URBAN DESIGN COMMITTEE

2. [Lincoln-Lancaster County Public Building Commission Parking Garage Expansion -UDR25041](#) – *Advisory Review*

URBAN DESIGN COMMITTEE STAFF REPORT

APPLICATION NUMBER	Urban Design Record #UDR25041
APPLICATION TYPE	Advisory review
ADDRESS/LOCATION	Public Building Commission Parking Garage Expansion (425 S 10 th St)
HEARING DATE	May 06, 2025
ADDITIONAL MEETINGS	-
APPLICANT	Kerin Peterson, kpeterson@lancaster.ne.gov
STAFF CONTACT	Arvind Gopalakrishnan, 402-441-6361, agopalakrishnan@lincoln.ne.gov

SITE LAYOUT PLAN
SCALE: 1" = 30'

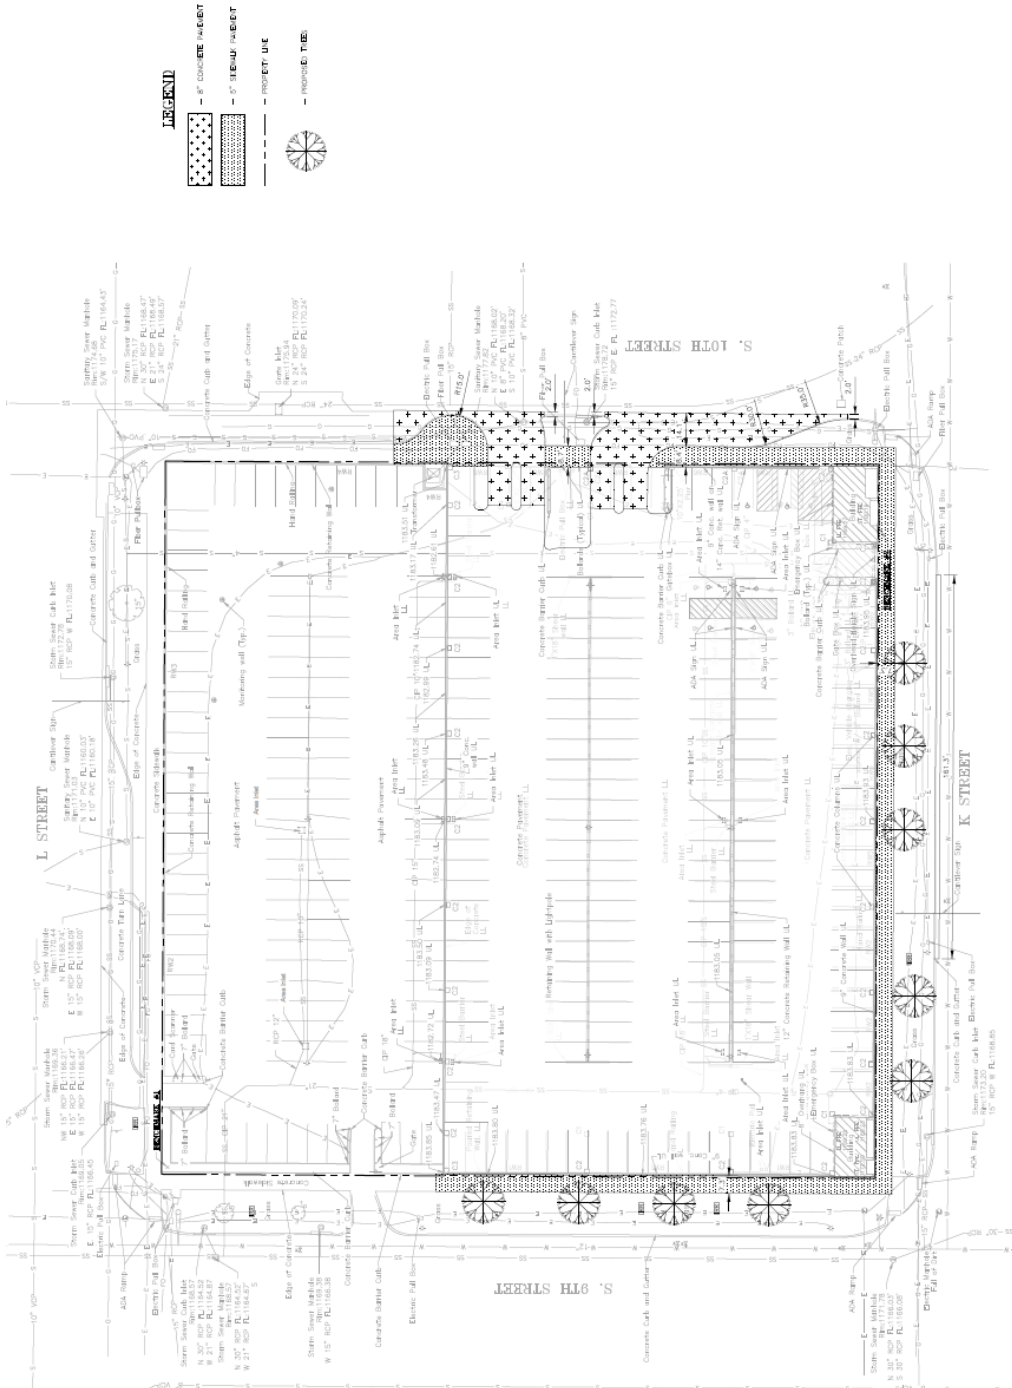
It is also noted that the proposed treatment of 10th Street does not show the proposed plan for 10th St outlined in the Downtown Corridors Master Plan. Staff recommends revising the site plan and accompanying drawings to maintain consistency and reflect the proposed streetscape improvements for this corridor.

BUILDING ELEVATIONS

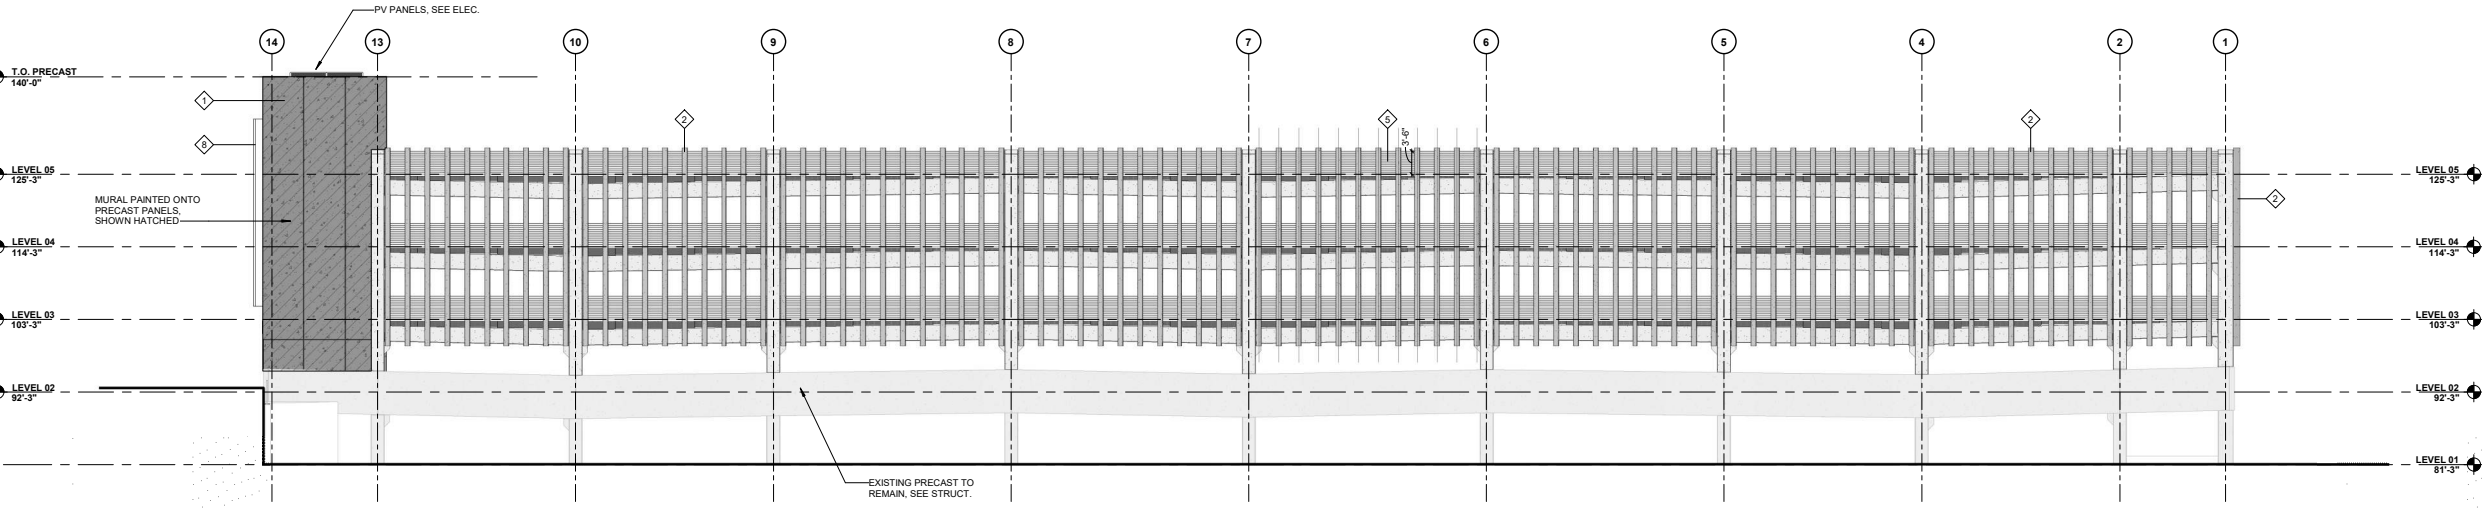
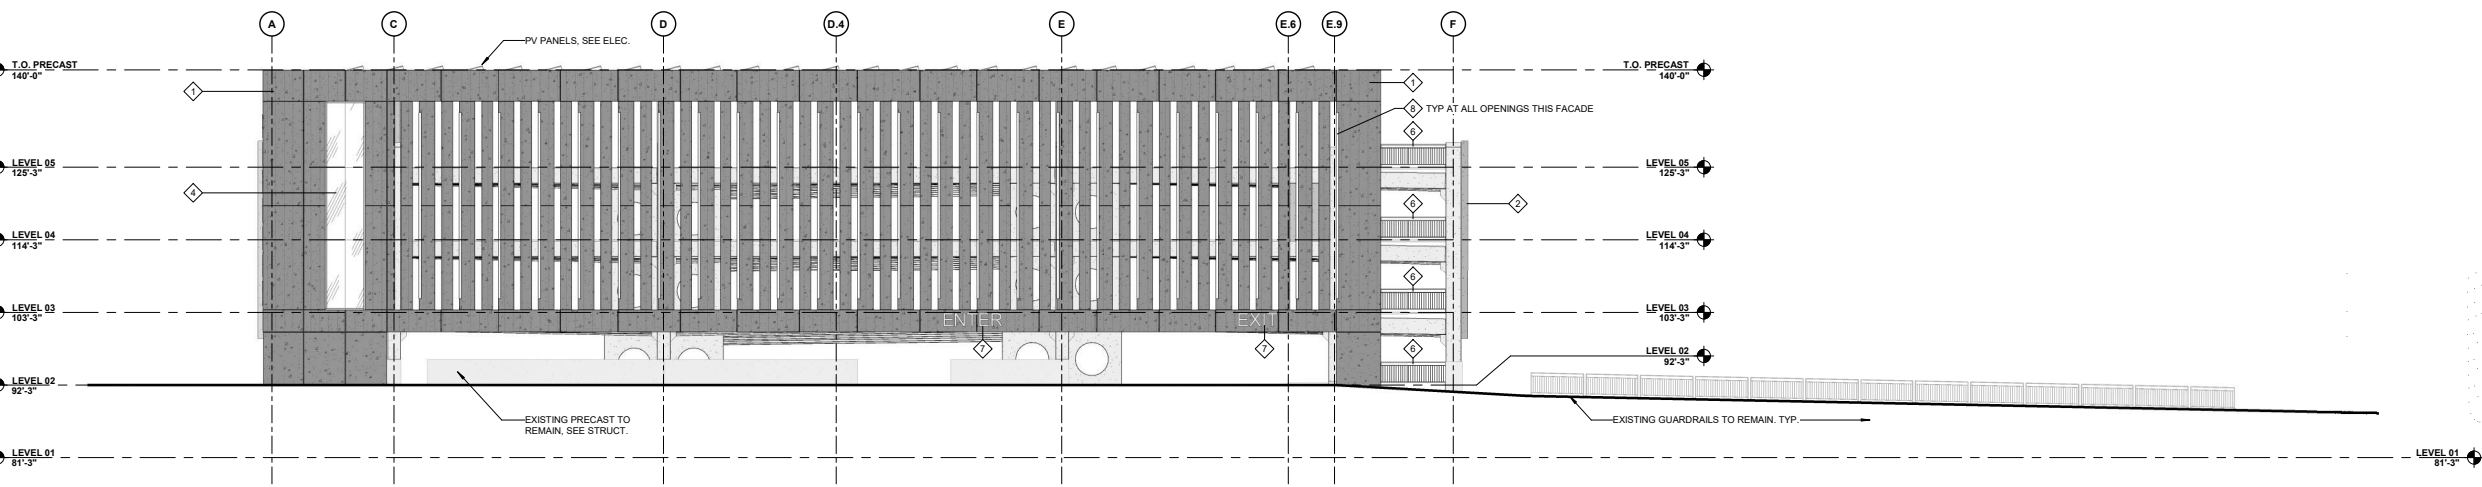
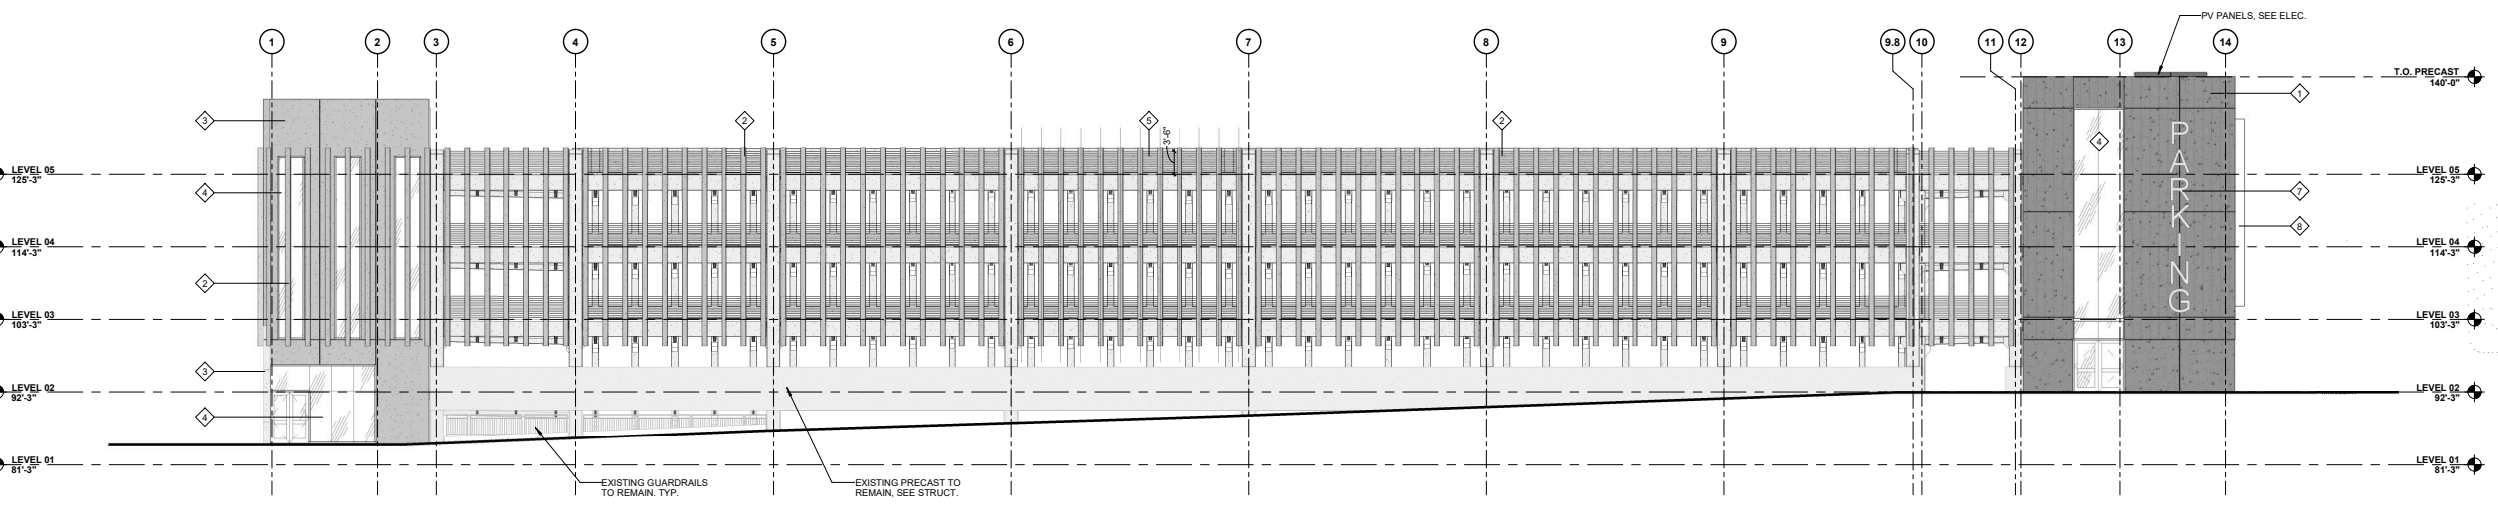
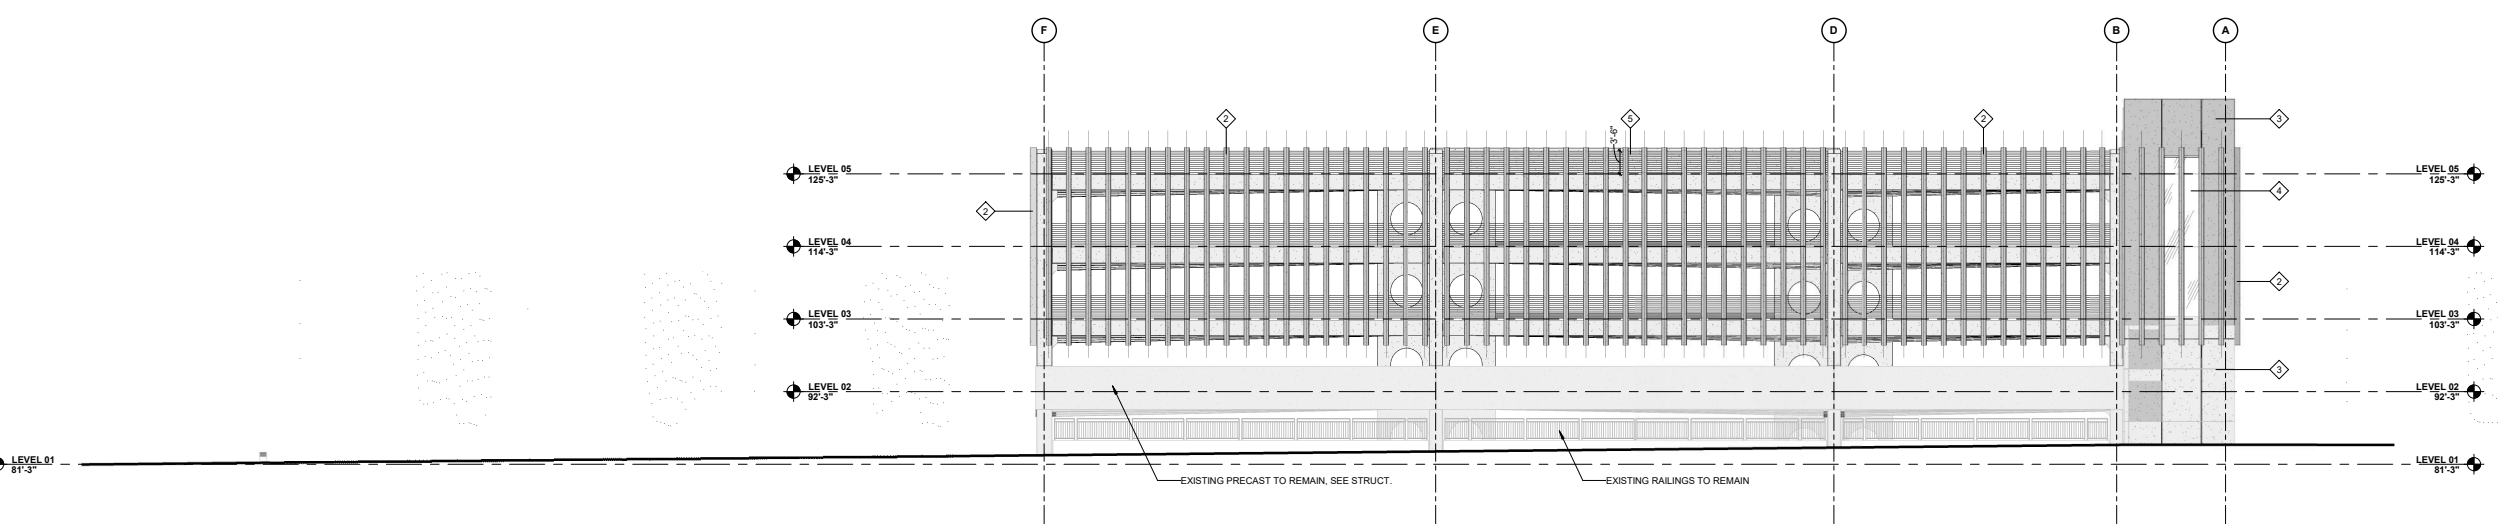
While the project incorporates precast concrete fins on the south, west, and north facades to reflect the architectural language of the existing PBC Campus, staff have identified opportunities for enhancement, particularly along the K Street and 9th Street elevations. These elevations are highly visible and serve as key gateways into Downtown. In the current proposal, their similarity to the adjacent structures does not create a distinctive or inviting entry experience.

To strengthen the identity and visual appeal of these façades, staff recommends the incorporation of additional design elements, such as perforated or colored metal panels, murals, colored fins, or other creative treatments that contribute to a more dynamic and engaging street presence.

Additionally, the current design proposal includes a mural at the corner of the east façade, and staff notes that this location is less visible in the broader urban context. We recommend relocating or replicating the mural concept on the more prominent K Street or 9th Street elevations, where it would have a greater visual impact and contribute more

meaningfully to the character of Downtown. Future development on the north sides of the block will also hide this mural.
